Office Action Summary	Application No. 10/606,104	Applicant(s) WANG ET AL.	
	Examiner Phillip Nguyen	Art Unit 2828

DETAILED ACTION

2. Claims 8-30 are rejected under 35 U.S.C. 102(e) as being anticipated by Kinoshita ('537).

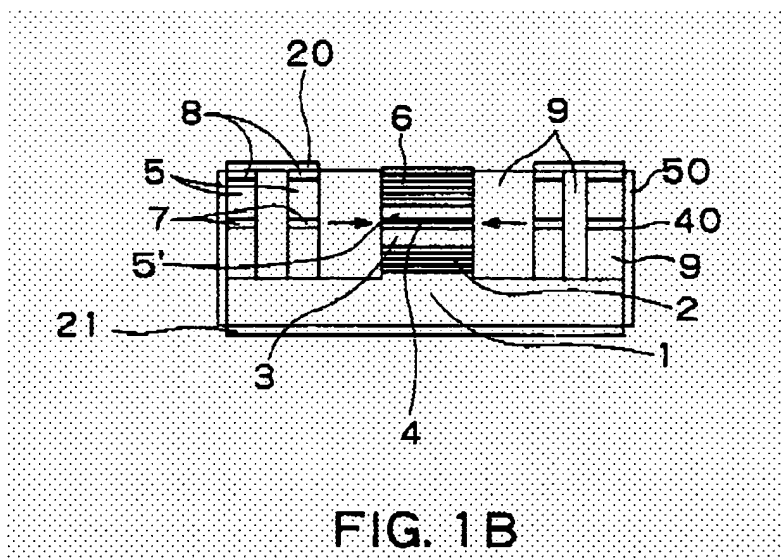
With respect to claims 8-9, 16-17, and 21, Kinoshita discloses in Fig. 1B (above) a vertical cavity surface emitting laser comprising a first mirror (DBR 2) having a plurality of layers including at least one pair of layers having an InP layer and an oxidized layer a cavity proximate to said first mirror; and a second mirror (DBR 6) proximate to said cavity (col. 4, lines 38-39 and lines 46-52). Kinoshita further discloses first mirror 2 being proximate to the substrate 1 which is made of InP (col. 4, line 32).

With respect to claims 10 and 18, since applicant fails to further limit the invention but only claim the output of the laser which is its capability and Kinoshita discloses the same product and structure, it is believed that the laser taught by Kinoshita would inherently produce the same output wavelength which is greater than 1200 nm. Kinoshita further discloses each of first and second stacks of layers 2 and 6 has a thickness of approximately $\frac{1}{4}$ of the optical wavelength (col. 1, lines 25-37).

With respect to claim 11, Kinoshita discloses said second mirror 6 comprising a plurality of layers having at least one InP layer (col. 1, lines 38-47).

With respect to claim 12, Kinoshita further discloses the cavity has at least one quantum well in active layer 4 (col. 4, line 34).

With respect to claims 13 and 22, Kinoshita discloses both first and second mirrors being selectively partially oxidized, and therefore it confines current (col. 4, lines 41-44).

With respect to claim 14, Kinoshita further discloses a first electrical contact 20 on said second mirror and a second electrical contact 21 on the substrate.

With respect to claim 15, Kinoshita discloses an Intracavity contact layer 3 disposed between the first mirror 2 and the cavity; a first contact on said second mirror 20 or any contact

surface such as the DBR 6 upper surface since applicant has fails to limit the claim invention to when claiming only a contact. The second contact is the upper surface of the contact layer 3.

With respect to claim 19, Kinoshita discloses the partially oxidized layer of first stack 2 being made of InAlAs (col. 1, lines 25-27 and col. 4, line 47).

With respect to claim 20, Kinoshita teaches every other layer of said second stack of layers comprise InP (col. 1, lines 44-47).
